Planning Director Staff Report– Hearing on September 8, 2022

JAIN RESIDENCE COASTAL PLANNED DEVELOPMENT (PD) PERMIT, CASE NO. PL17-0005

County of Ventura
Planning Director Hearing
Case No. PL17-0005
Exhibit 4 Mitigated Negative
Declaration, Comments and Staff's
Responses to Comments

P-2

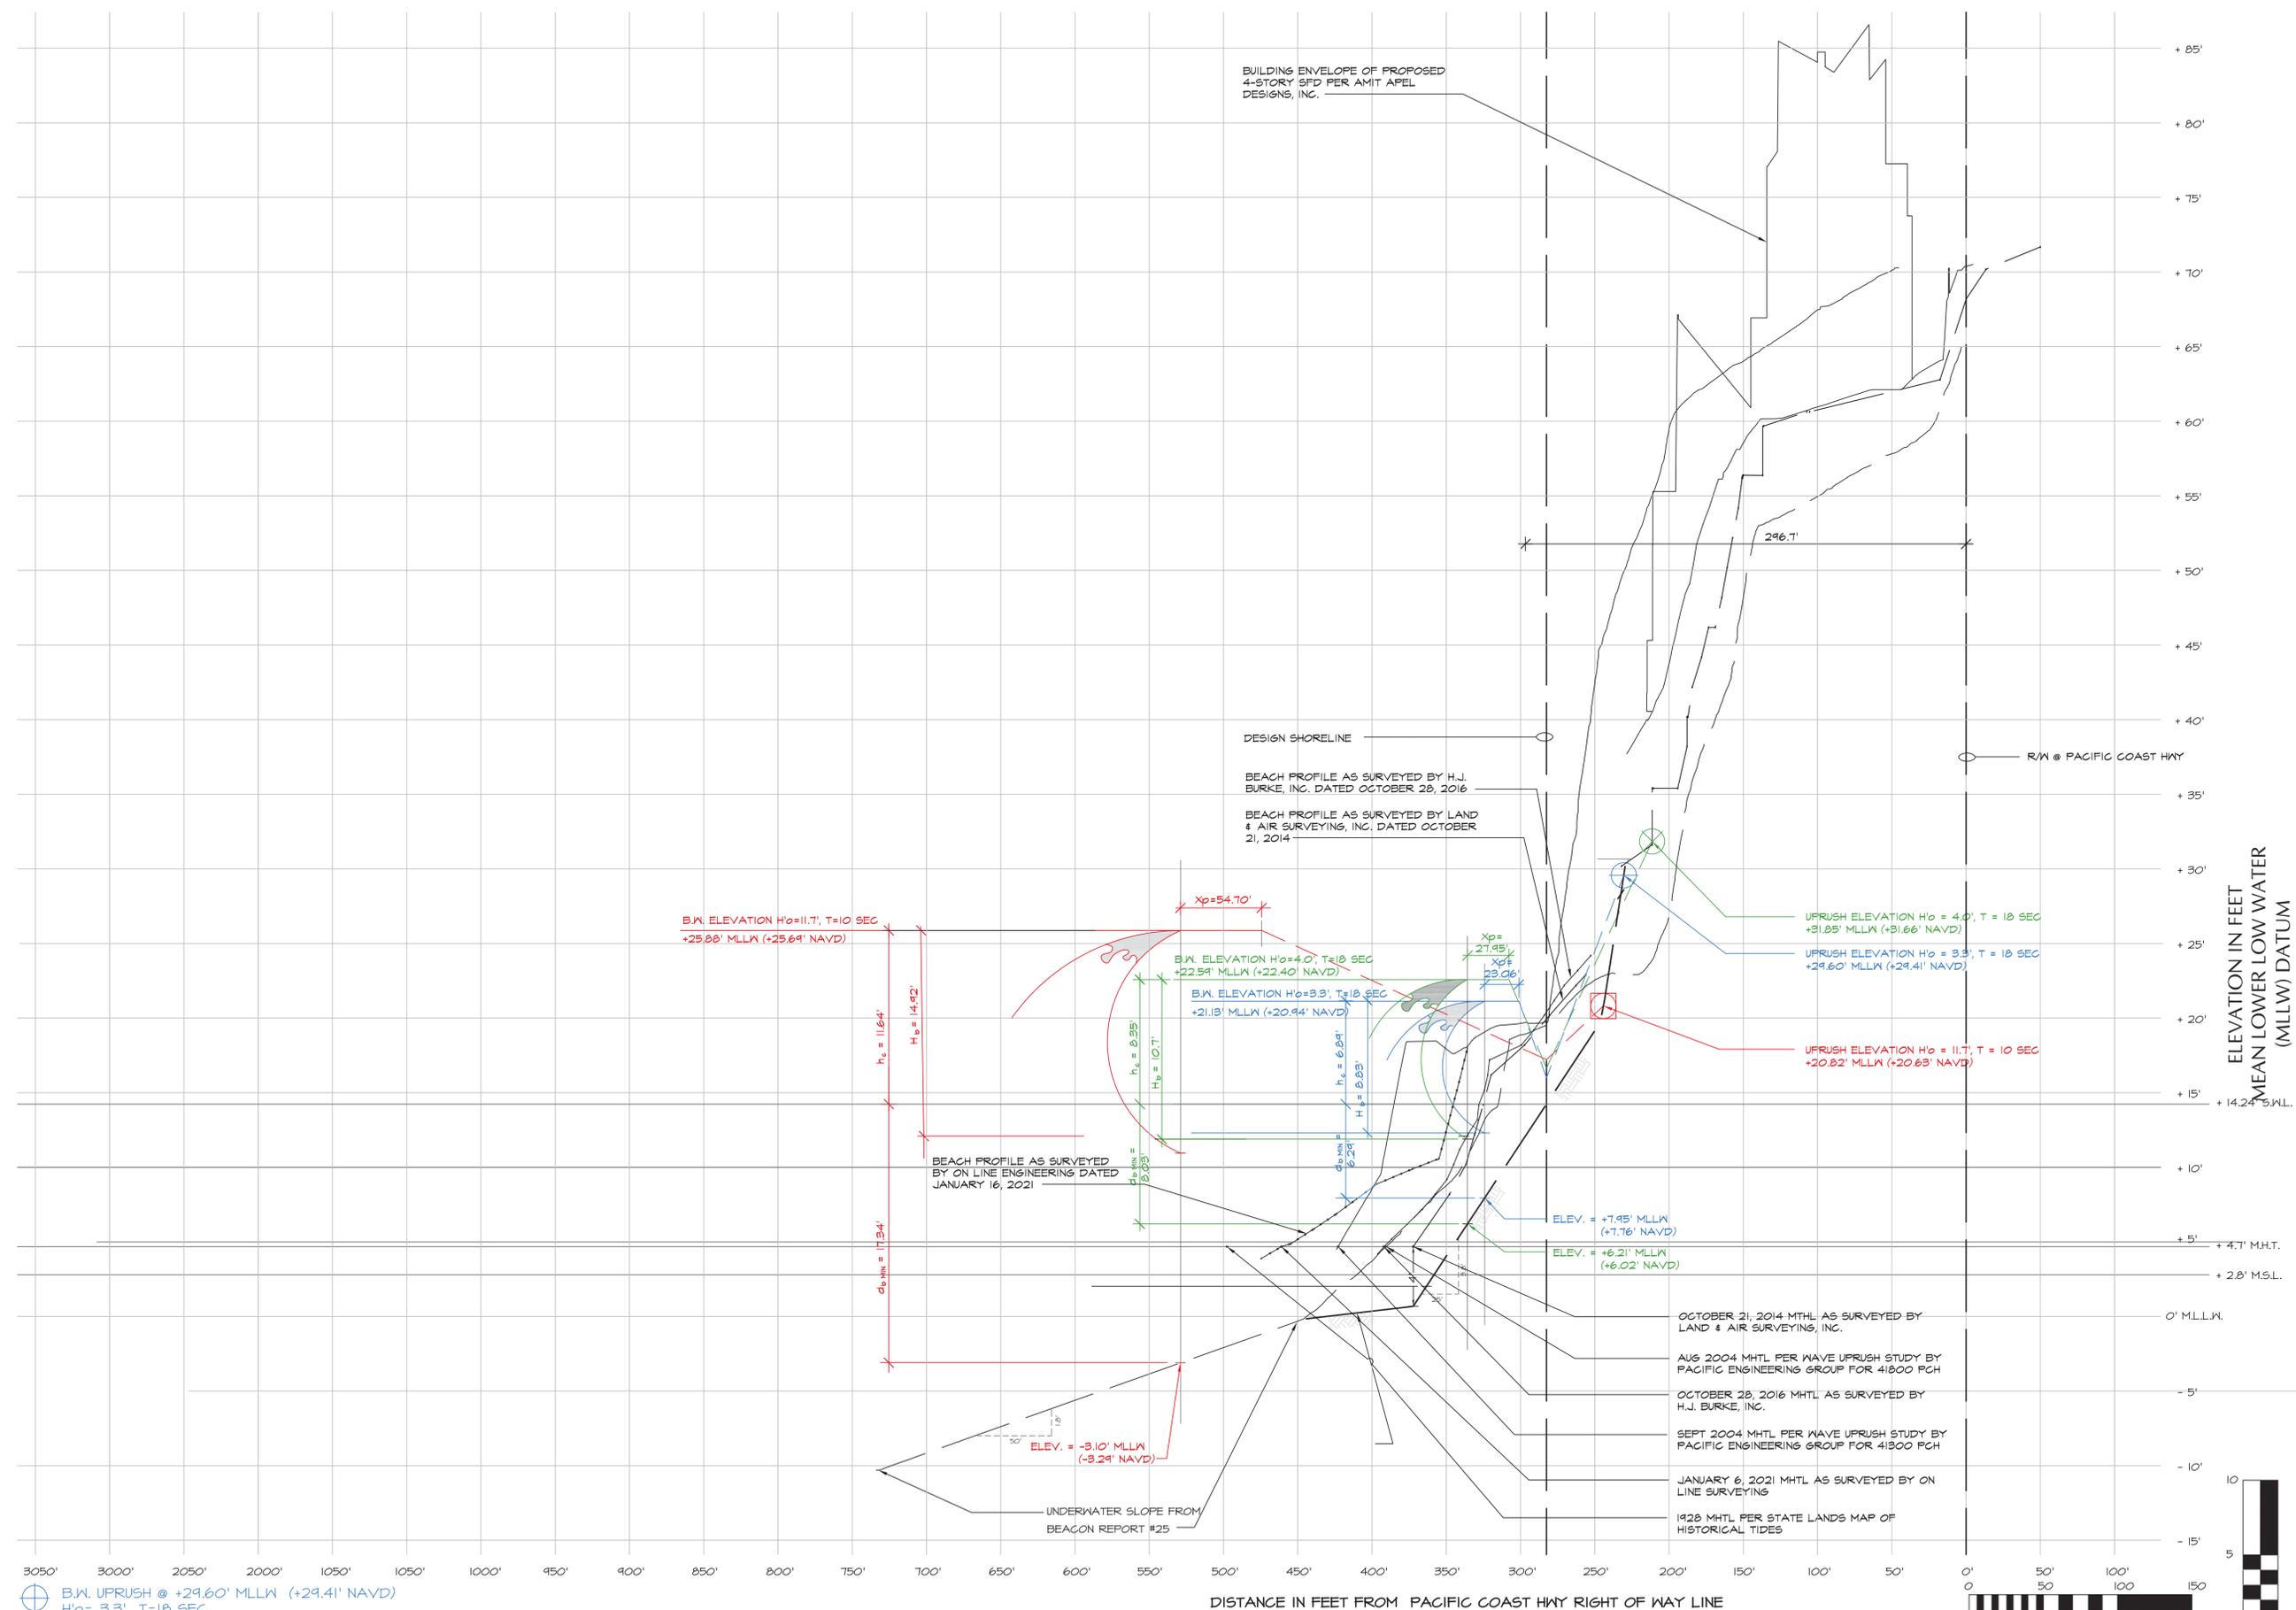
- 2. Response to Comment 2:** The commenter states that the site is located in an area extremely vulnerable to coastal hazards and flooding. The commenter references Section 30253 of the Coastal Act which requires the minimization of risks to life and property. The commenter states that the staff report for the Project indicates the structural members of the proposed ADU would be subject to wave action. As analyzed in the Planning Director Staff Report (Exhibit 6, Item 6), the area is suitable for the proposed development and free of significant risk from the range of considerable hazards (flooding, wave attack, geological hazards, fire, etc.). With respect to the ADU being subject to wave action, as disclosed in the response to comments document attached to the MND (Exhibit 4, Revised ISMND Item 17b-14) the piles upon which the ADU will be built will be subject to wave action at the end

of the 75 year design life of the structure with a negligible wave force of 4.94 lbs. per square foot at a depth of 0.31 feet per the Coastal Engineer of record for the proposed Project (Exhibit 7). Other solid improvements have been removed from the landward extent of the third wave condition (B.W. Uprush H'o = 4.0', T + 18 Sec) uprush elevation, located 211.4 feet from the right-of-way for Pacific Coast Highway. No further revisions to the Project are required to address this comment.

DRAWING NO.
W0.01

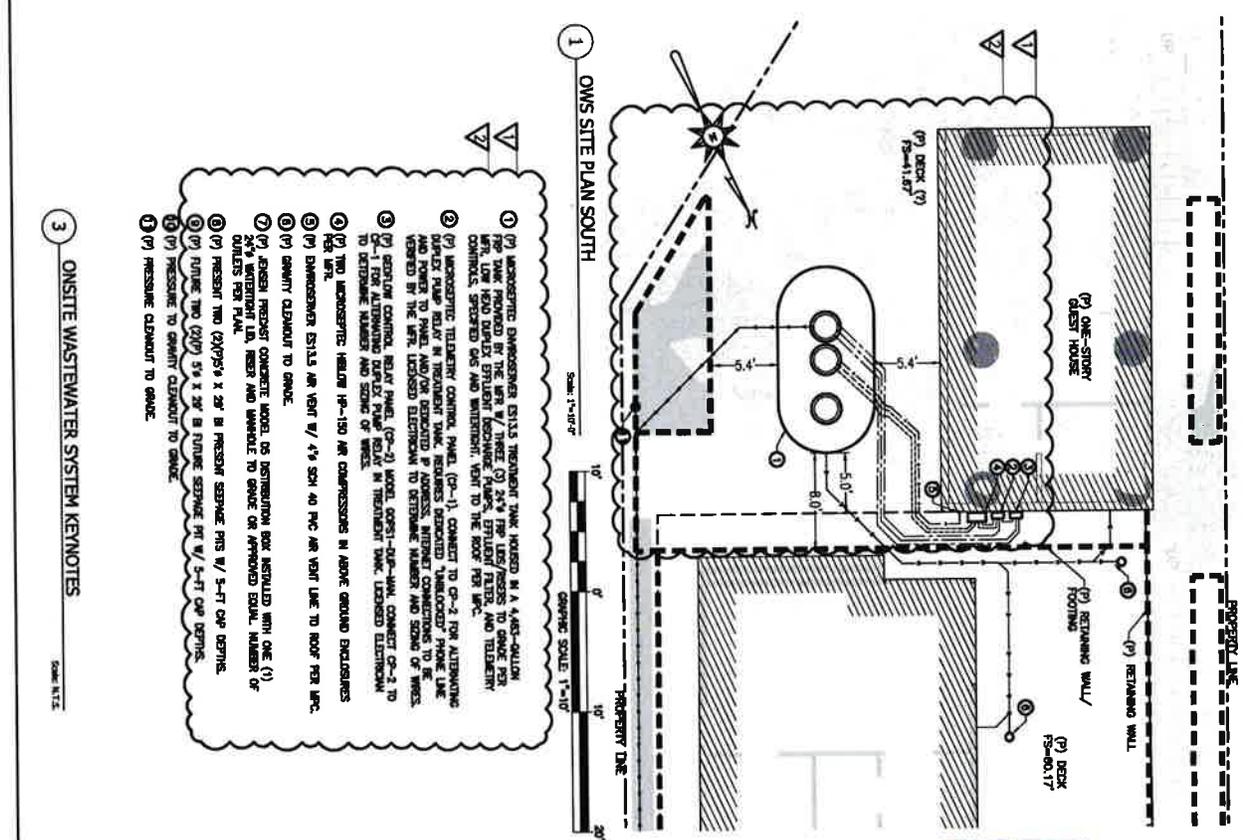
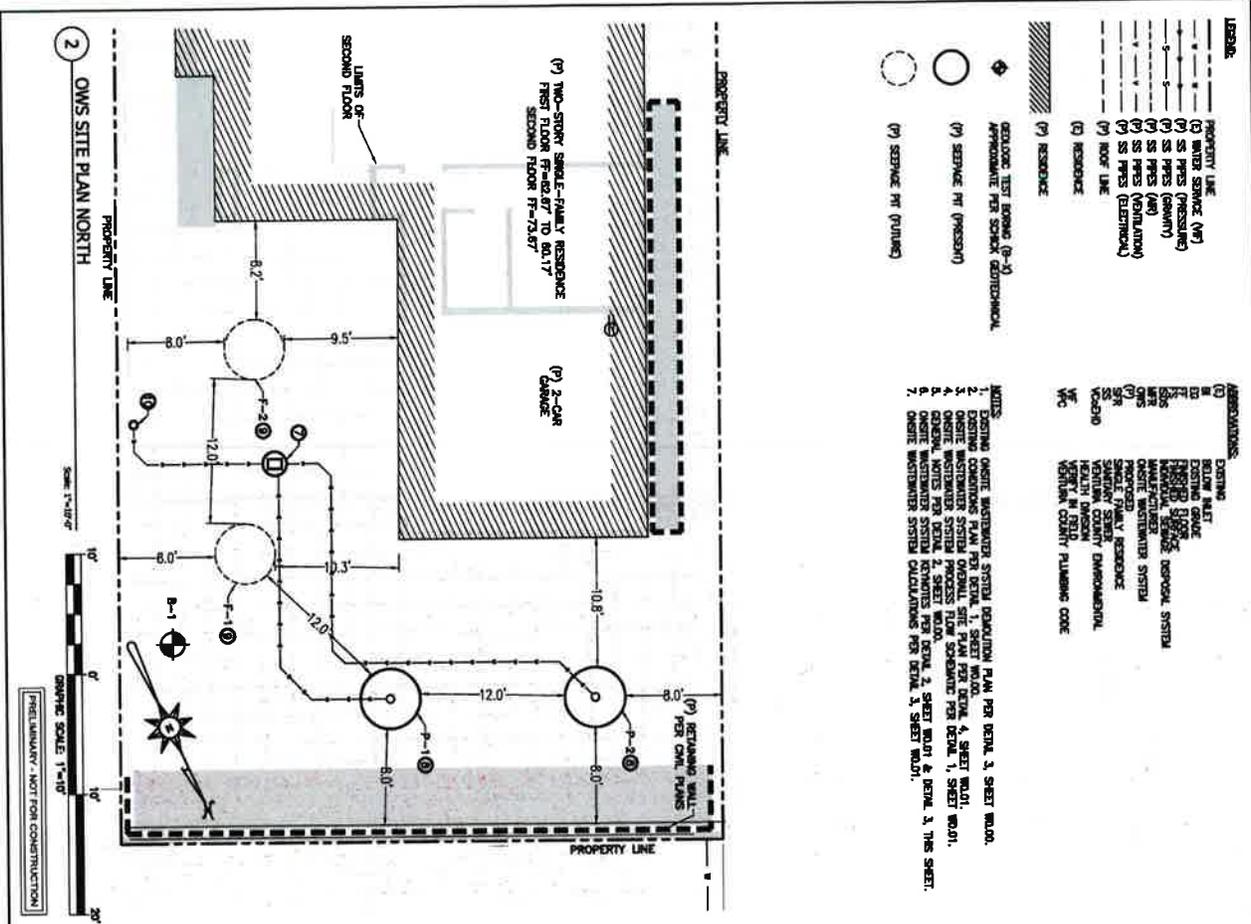
4. **Response to Comment 4:** The commenter states that the ISMND for the Project (Exhibit 4) was revised to address the stability of the slope area occurring on the site but failed to clarify if analysis by a qualified professional was completed in order to determine if this site constitutes a bluff, and to determine potential blufftop setbacks. In response to this item the Planning Division consulted with the Ventura County Public Works Agency (PWA) Engineering Geologist, Jim O'Tousa Certified Engineering Geologist CEG1393. Mr. O'Tousa previously conducted agency review of the Project on behalf of PWA for review of preliminary grading, geotechnical reports, and structural design. Mr. O'Tousa determined that based upon his review of the submitted project Plans (Exhibit 3) and the Geological and Soils Engineering Investigation (Exhibit 8), the site is stable, including manufactured slope areas. The Geological and Soils Engineering Investigation indicates that the subject property has been modified through previous grading activities and indicates the presence of fill material at a depth of 5 to 9 feet within the proposed

development envelop (See Drawing W0-01 for test pit locations, Exhibit 8). Mr. O'Tousa has reviewed the Geological and Soils Engineering Investigation and concurred with the determination in the report that the proposed Project is grossly stable to a factor of safety in excess of 1.5 (static) and 1.1 (pseudo static). Consistent with the applicable requirements of the Local Coastal Program and the January 16, 2003 Memorandum from Mark Johnson, Staff Geologist to the California Coastal Commission¹, the slope areas present on the Project site are stable, do not constitute bluff, and no slope setback is necessary for the Proposed project. As analyzed by Mr. O'Tousa, while the site contains sloping segments with flat segments (4 segments measured on Exhibit 3, Sheet C2.3), it does not contain any sheer or defined bluff face and is not presently subject to retreat or erosion. The toe of the manufactured sloping segment defined by Mr. O'Tousa is approximately 235 feet landward of the October 28, 2016 surveyed Mean High Tide Line and outside of the areas determined to be subject to Coastal Hazards (Exhibit 7). Consistent with the findings and analysis with the Planning Director Staff Report and its exhibits, the proposed single-family dwelling and ADU may be constructed as proposed consistent with the requirements of the Local Coastal Program and Coastal Act.
